BPC CENTRAL SEWERSHED PACKAGE 6 – CIPP PROJECT

Solicitation Number: CO-00479

Job No.: 20-4503

ADDENDUM 1

SITE 10
COMPKEY: 986409
SEWER PLAN
STA 10+00.00 TO END

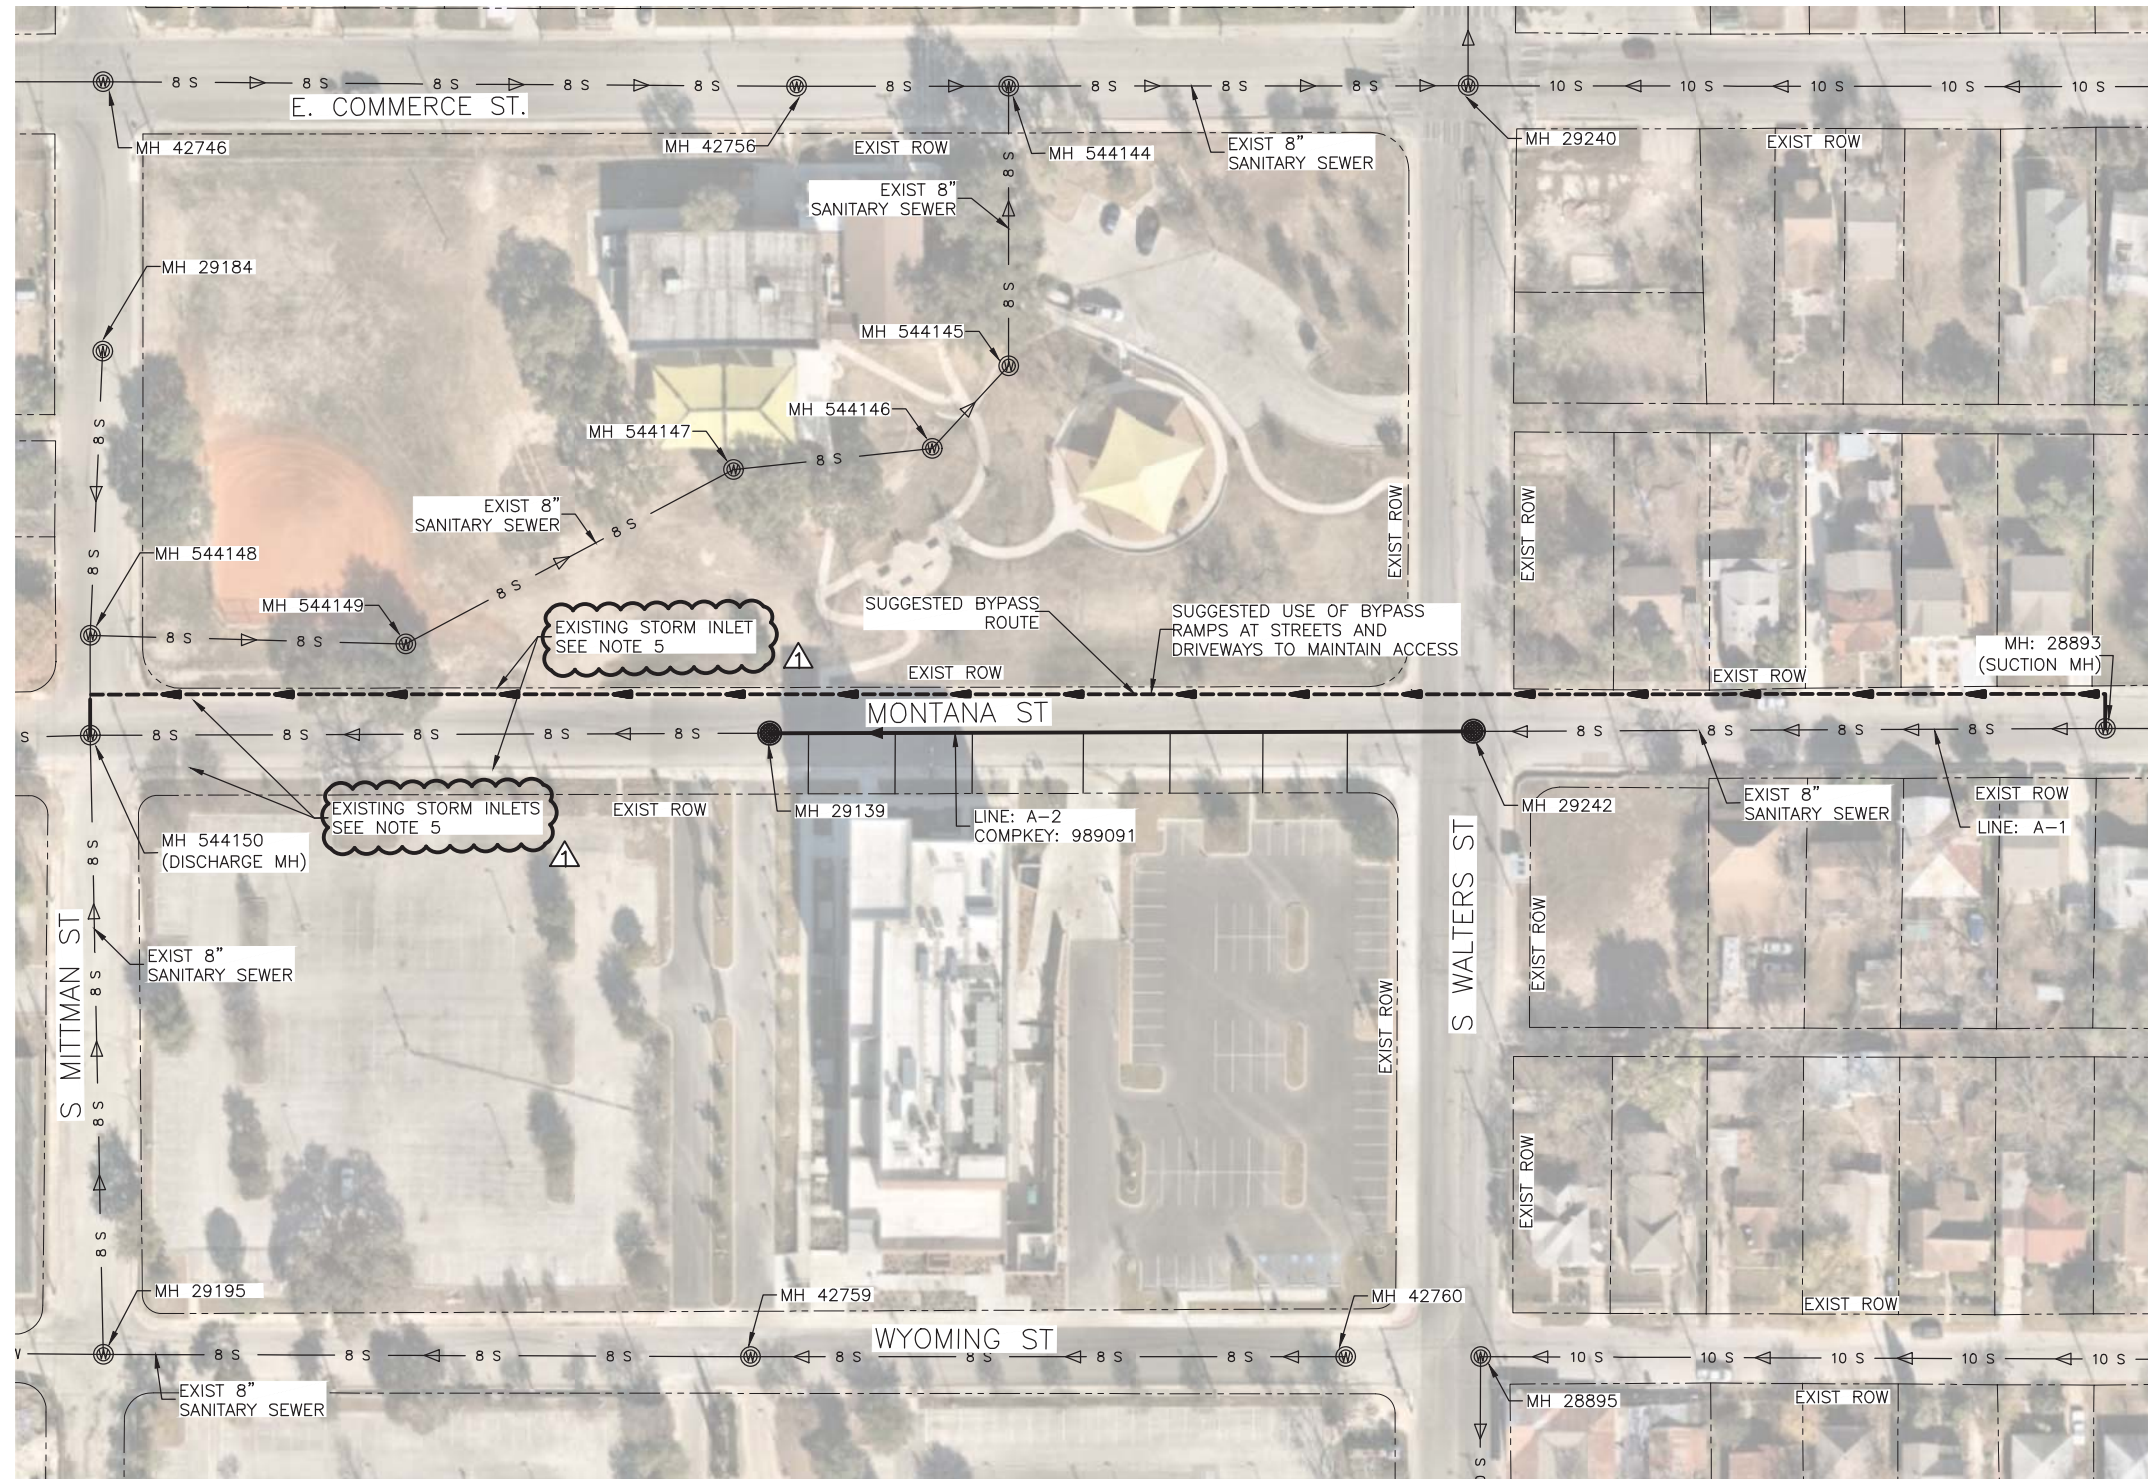
5. Remove and replace Page S63 to the plans with the page dated 9/19/2021 as the storm drain within Mittman St. has been added to the sheet.
6. Remove and replace Page S78 to the plans with the page dated 9/19/2021 as Note 5 regarding existing storm inlets has been added to the sheet.

NO	DATE	DESCRIPTION	DWG	CHK
9/17/2021	ADDED STORM DRAIN		LG	JAS

SITE 16
COMPKEY 994484
SEWER PLAN
STA 210+00.00 TO STA 213+00.00
SHEET 1 OF 2

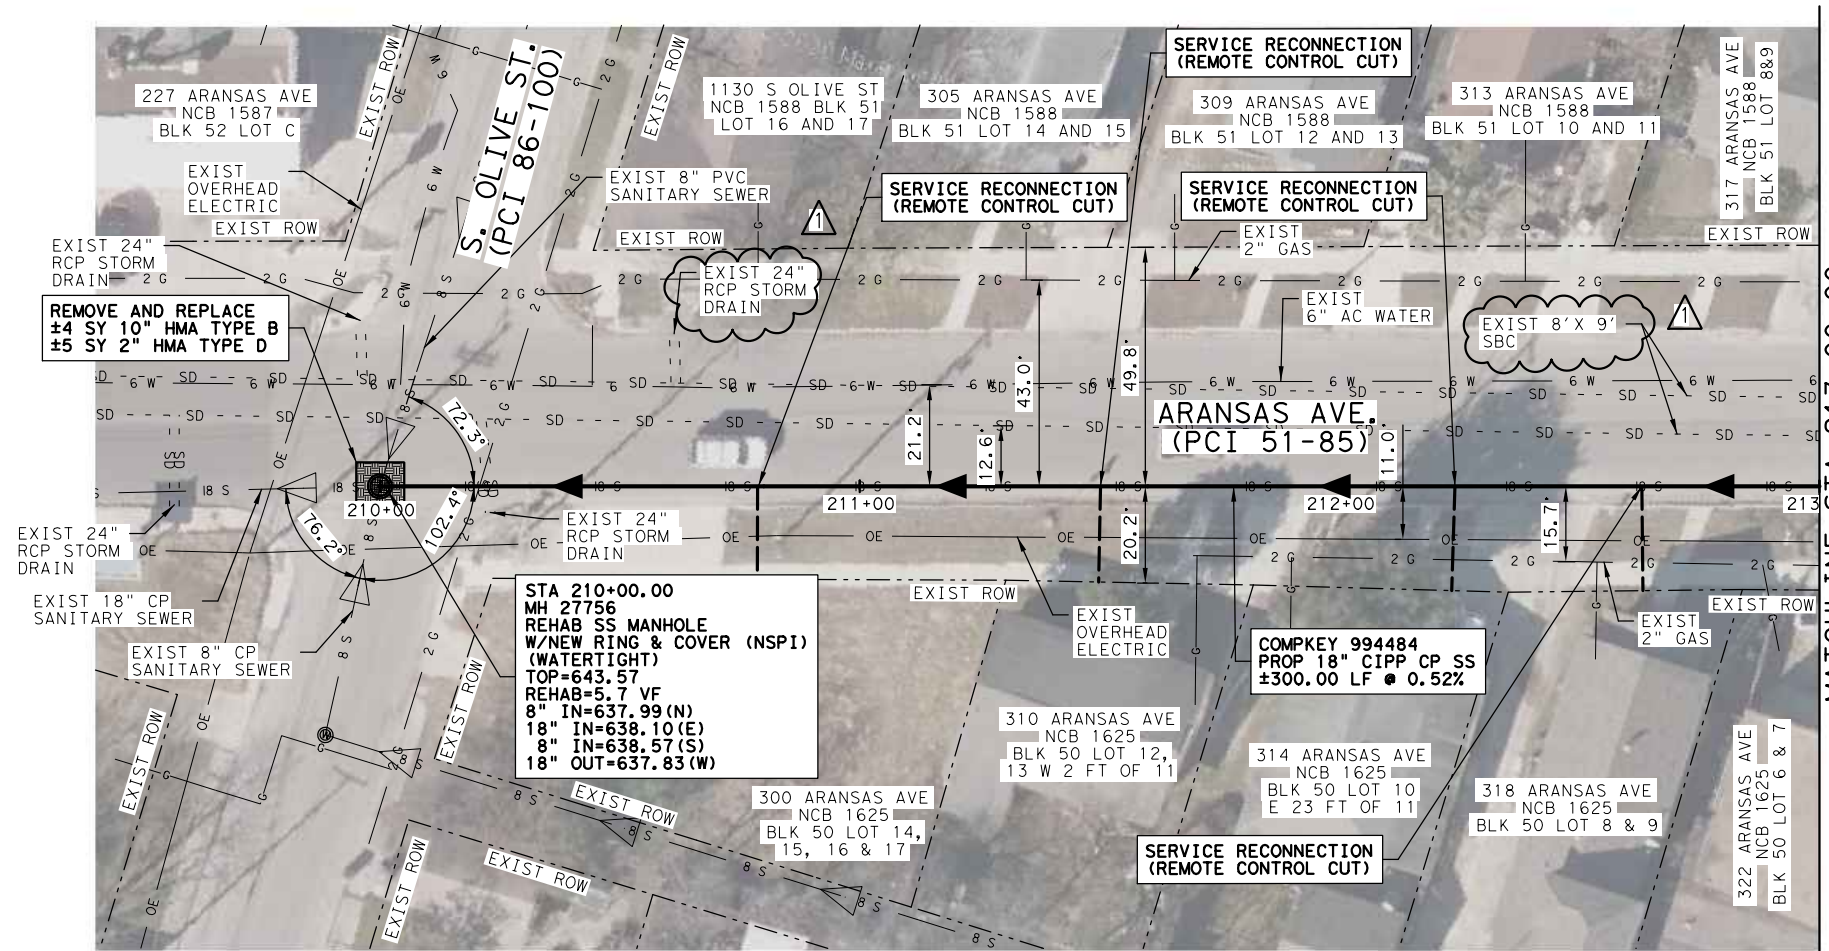
7. Remove and replace Pages S111 and S112 to the plans with the page dated 9/16/2021 as the storm drain within Aransas Ave. has been added to the sheets.

NO	DATE	DESCRIPTION	DWG	CHK
1	9/16/21	ADDED STORM DRAIN

SITE 16
COMPKEY 994484
SEWER PLAN
STA 213+00.00 TO END
SHEET 2 OF 2

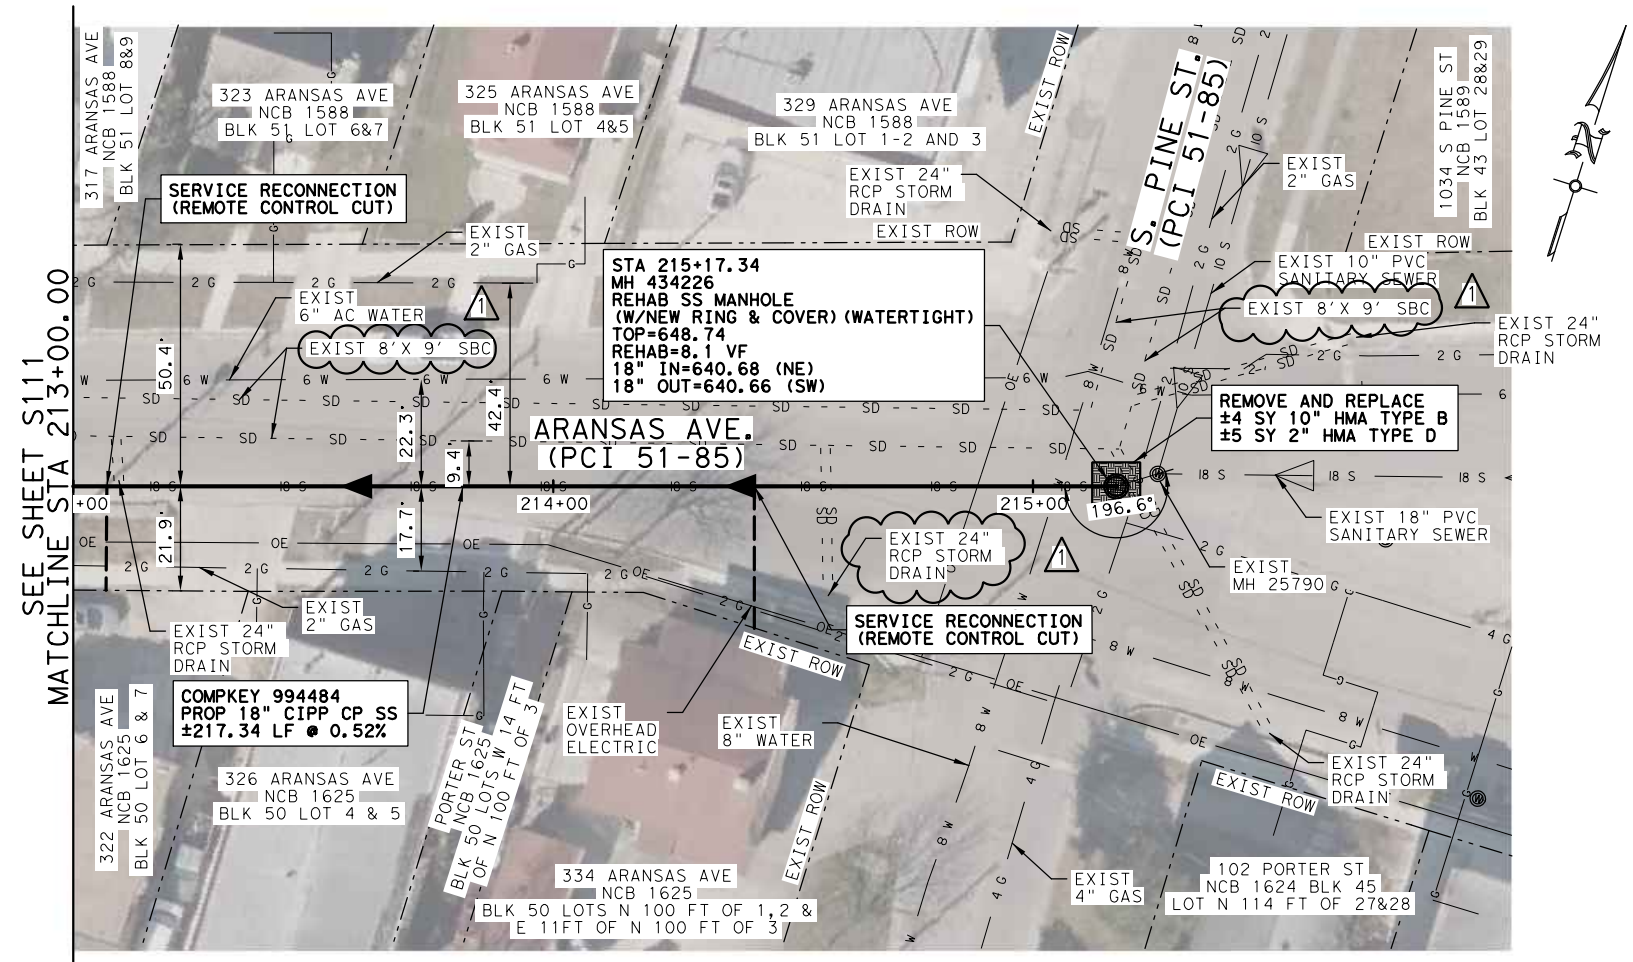
NO	DATE	DESCRIPTION	DWG	CHK
1	9/16/21	ADDED STORM DRAIN

SITE 20
COMPKEY: 988709
SEWER PLAN
STA 10+00.00 TO END

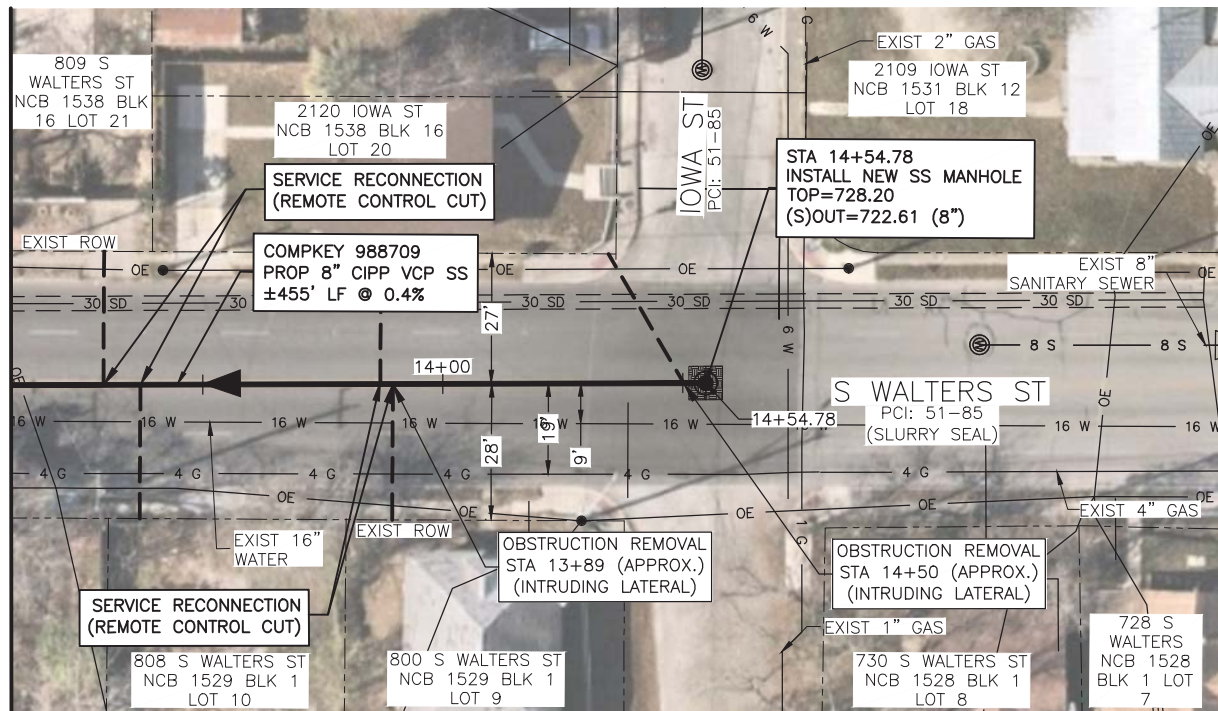
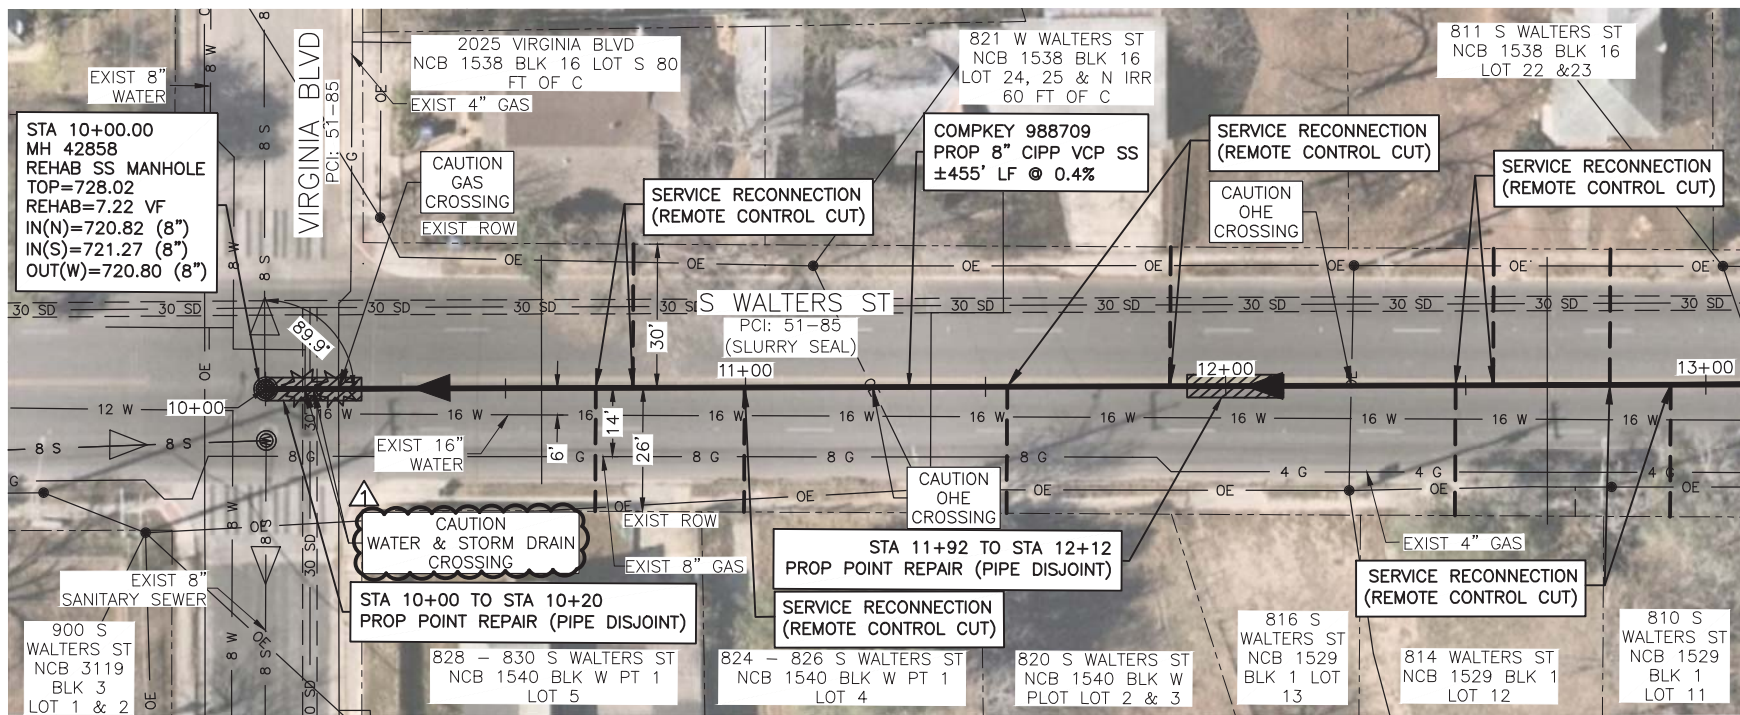
8. Remove and replace Page S133 to the plans with the page dated 9/19/2021 as the storm drain within Walters St. and Virginia Blvd. has been added to the sheet.

NO	DATE	DESCRIPTION	DWG	CHK
1	9/17/2021	ADDED STORM DRAIN	LG	JAS
